HISTORIC AND DESIGN REVIEW COMMISSION

HDRC CASE NO: 2022-145
ADDRESS: 922 NOLAN ST
LEGAL DESCRIPTION: NCB 1666 BLK J LOT 7
ZONING: R-5, H
CITY COUNCIL DIST.: 2
DISTRICT: Dignowity Hill Historic District
APPLICANT: Juan Osorio /OSORIO PROPERTIES LLC
OWNER: Juan Osorio /OSORIO PROPERTIES LLC
TYPE OF WORK: Fencing, fenestration modifications, amendment to a previously approved addition, porch modifications, column installation, window replacement, site work
APPLICATION RECEIVED: April 07, 2022
60-DAY REVIEW: Not applicable due to City Council Emergency Orders
CASE MANAGER: Edward Hall
REQUEST:

Historic and Design Review Commission
Design Review Committee Report

ROOF PLAN

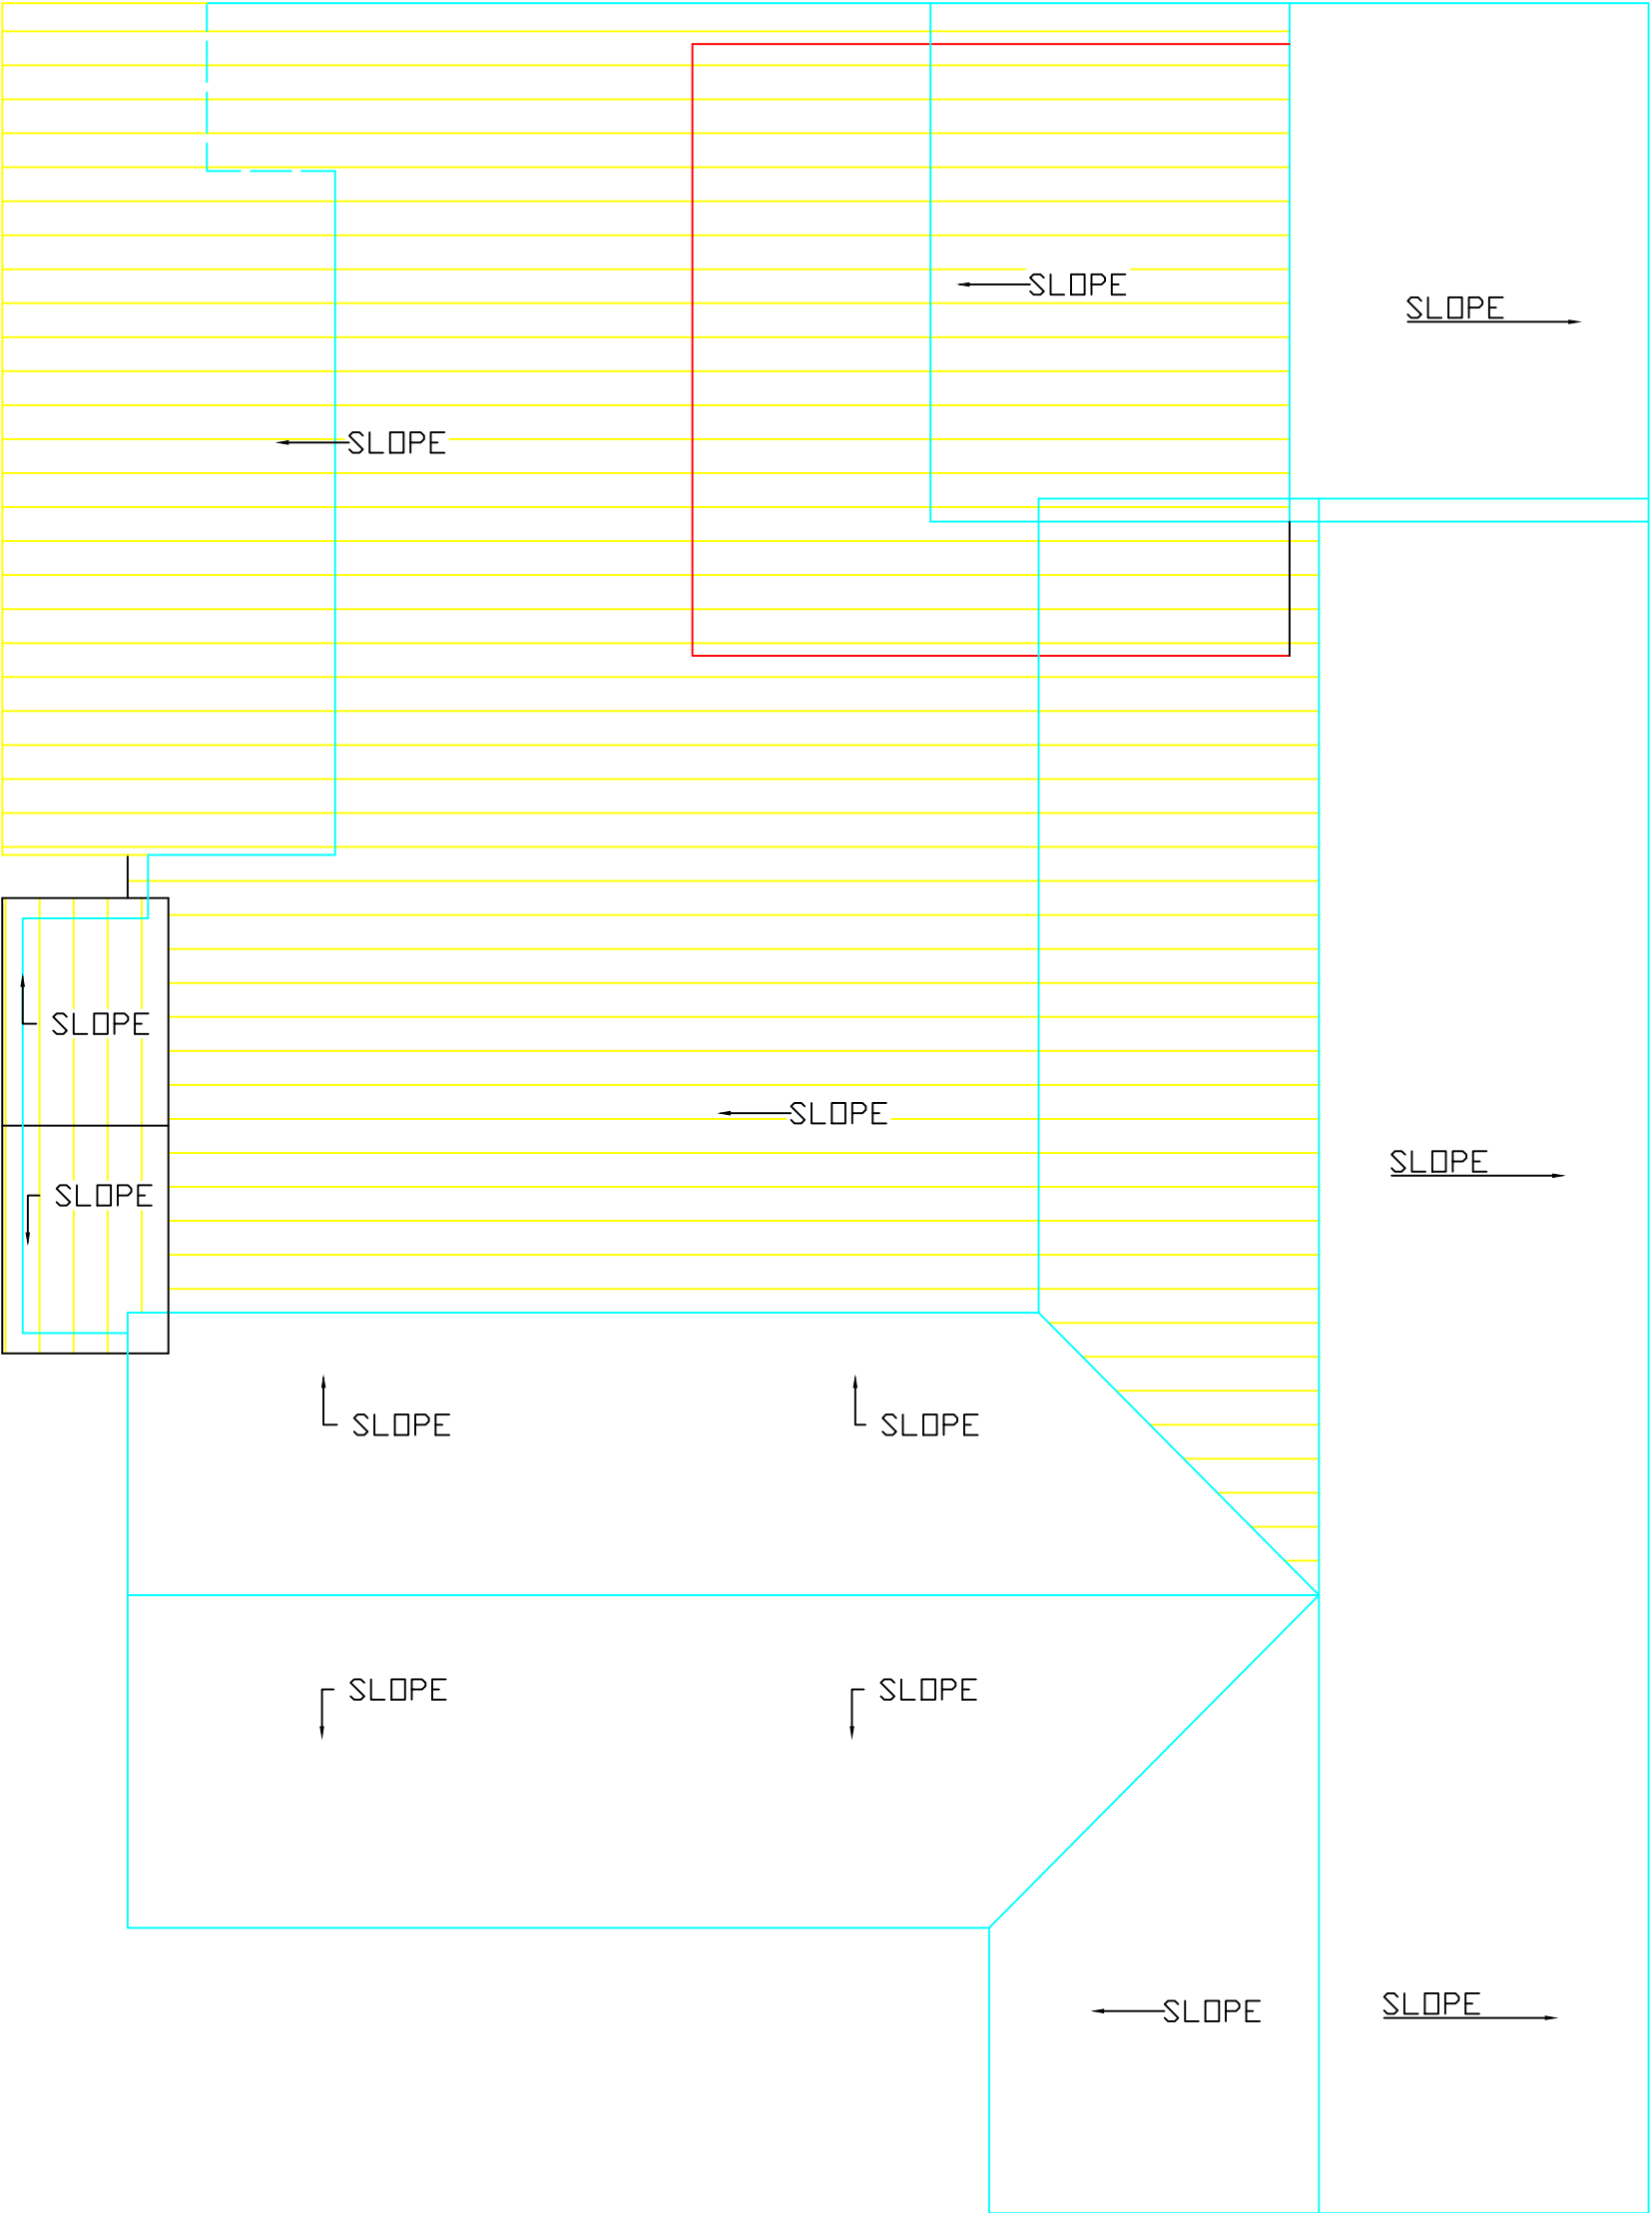
- l. ADDITION/ROOF MODIFICATION – The applicant has proposed to construct a rear addition that features profile modifications to the original roof form and modified fenestration profiles. At the September 2, 2022, HDRC hearing, OHP staff did not recommend approval of the proposed roof form as it featured a contemporary roof form. Staff recommends that the applicant propose a gabled roof form, consistent with the Guidelines. The commission approved the modification with the stipulation that the final construction documents be reviewed by OHP staff to ensure consistency with the OHP's recommendation. Staff finds the construction roof form to be inconsistent with the Guidelines.

8. Staff does not recommend approval of item #8, the construction of a rear addition with a shed roof form. Staff recommends the applicant install a gable roof. Staff finds the modified fenestration profile of the addition to be appropriate.

Rear addition- Okay as constructed, add gutters. AMG, GV, JC agree

DOOR / WINDOW SCHEDULE

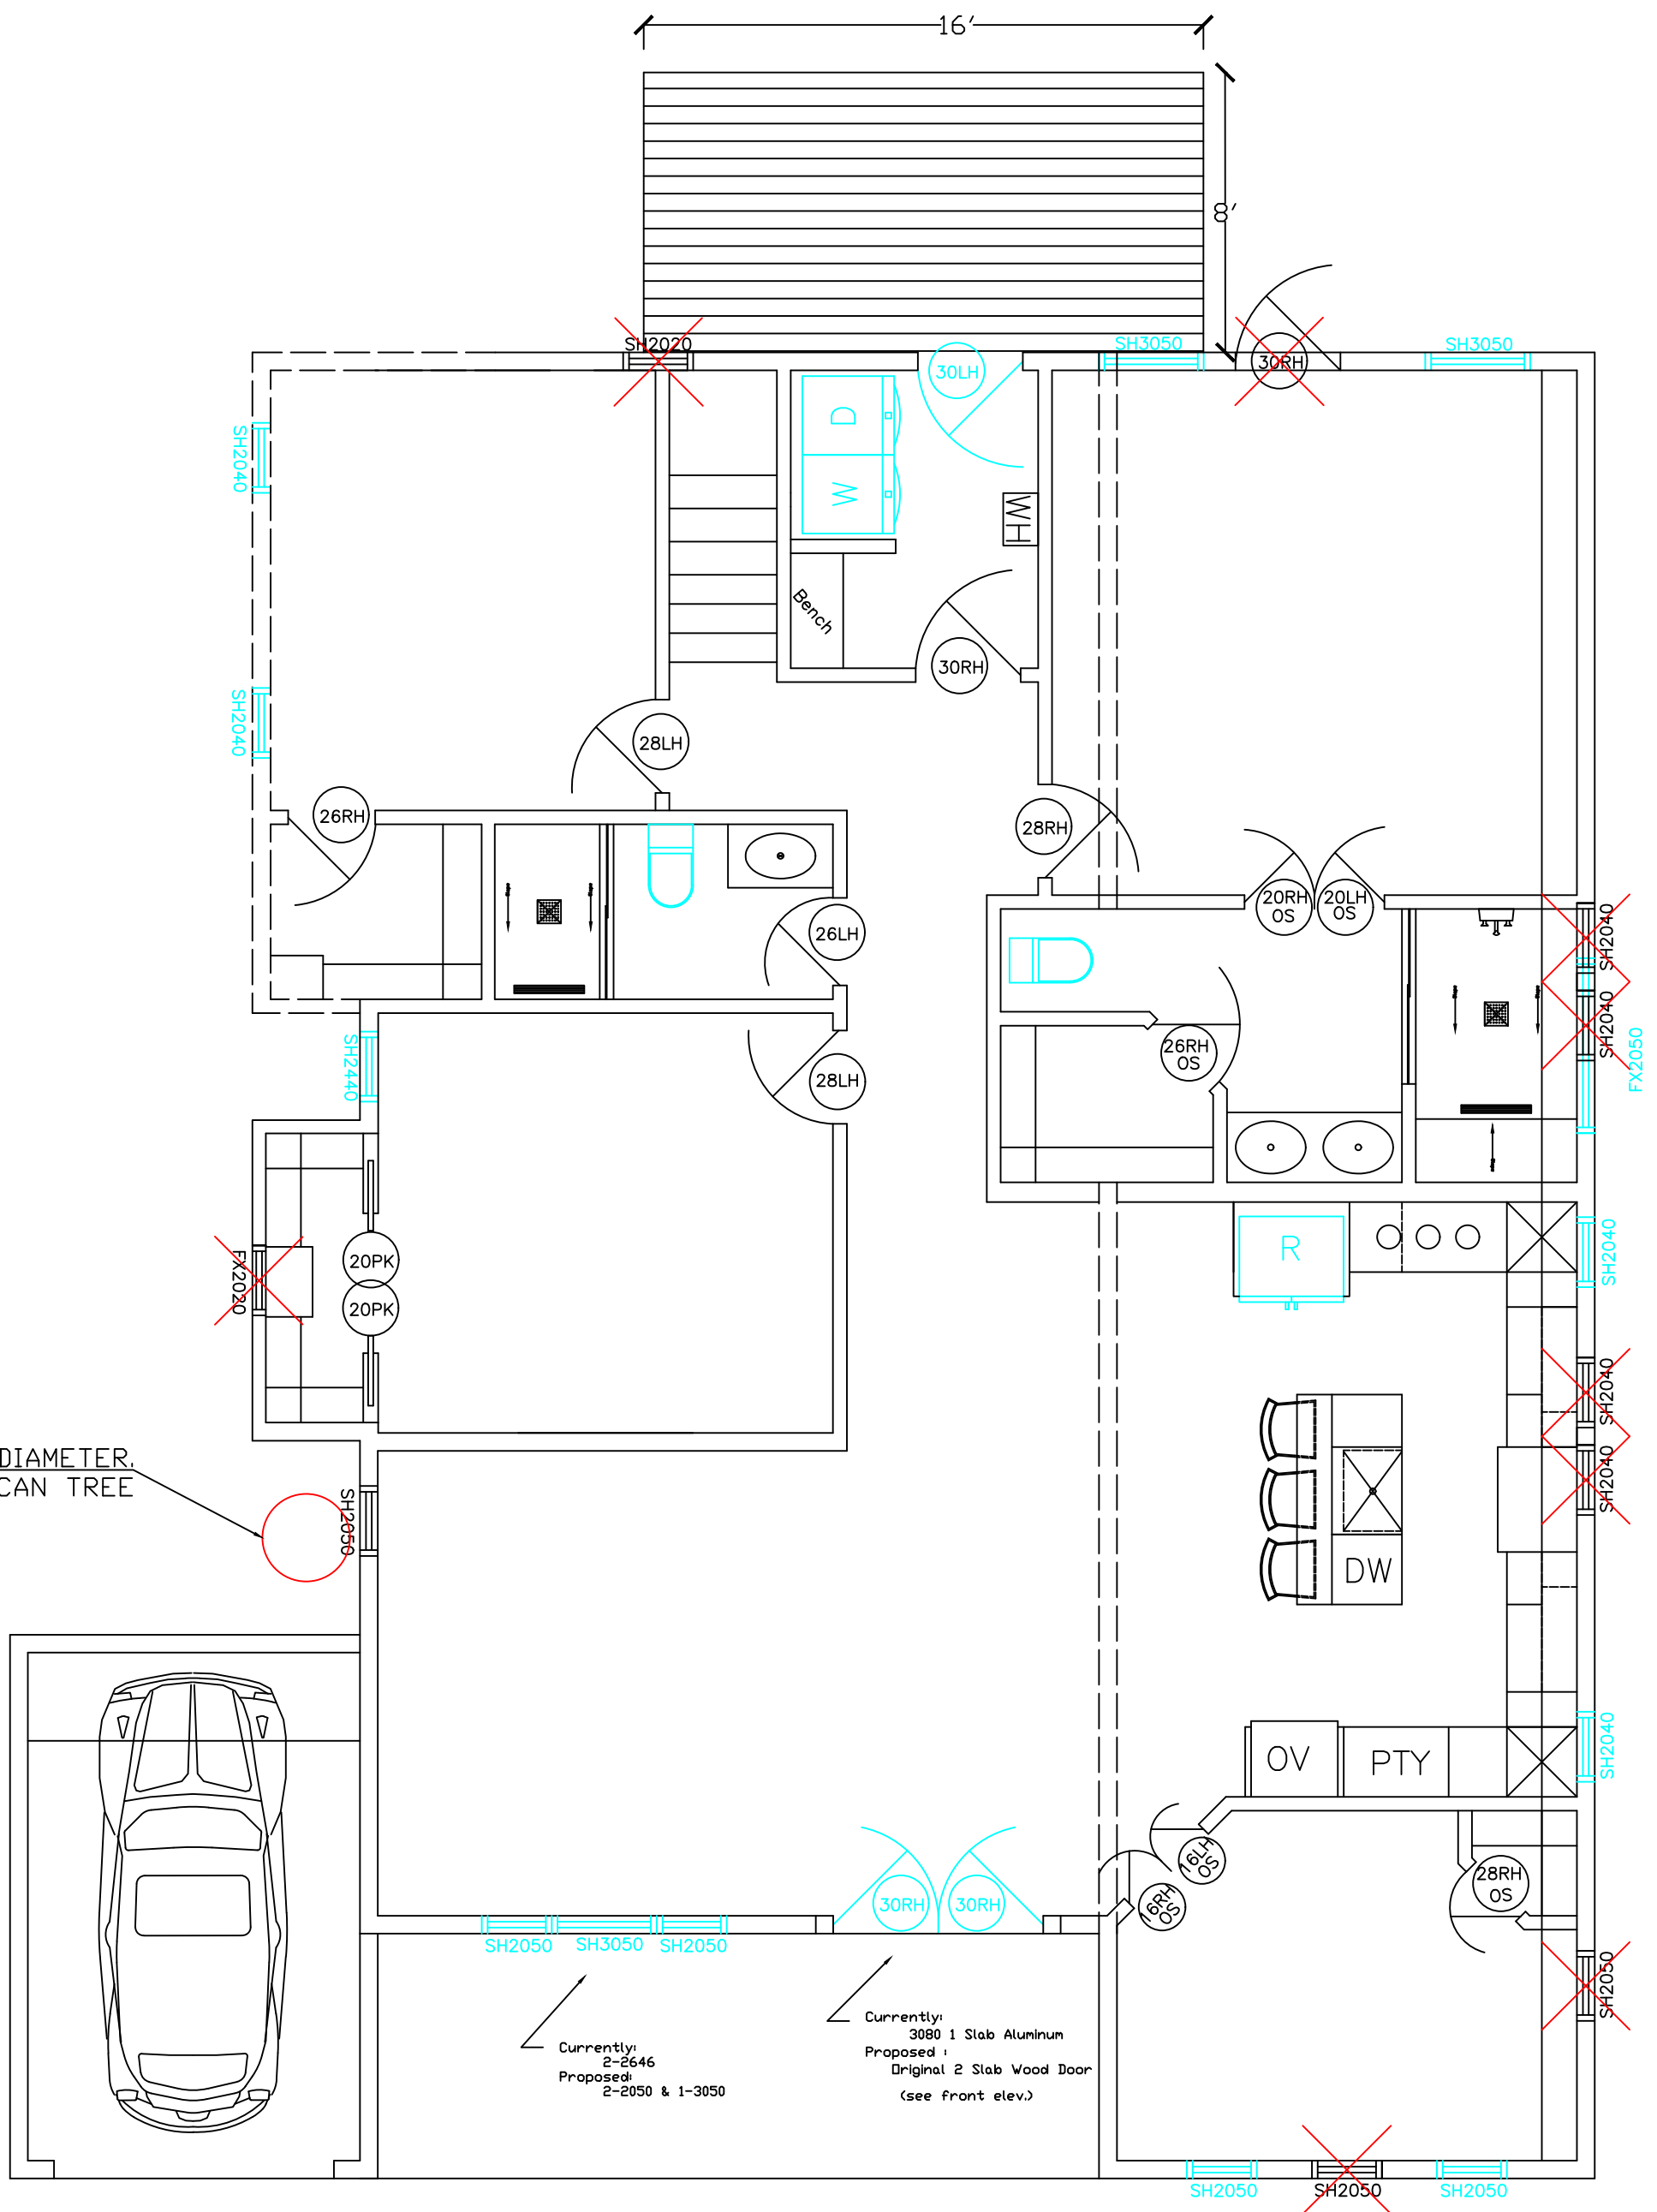
- e. FENESTRATION MODIFICATIONS – The applicant has proposed modifications to the existing fenestration profile including the removal of window openings on the front porch, modifications to the size of window openings, the removal of transom window openings and the widening of the historic front door openings. Per the Guidelines for Exterior Maintenance and Alterations 6.A.i. existing window and door openings should be preserved. The fenestration modifications are neither appropriate nor consistent with the Guidelines. Staff finds that all modifications to the original fenestration profiles should be restored.

1. Staff does not recommend approval of item #1, removal of window openings on the front porch, modifications to the size of window openings, the removal of transom window openings and the widening of front porch doors based on finding e. Staff recommends all original openings be restored to their original profiles.
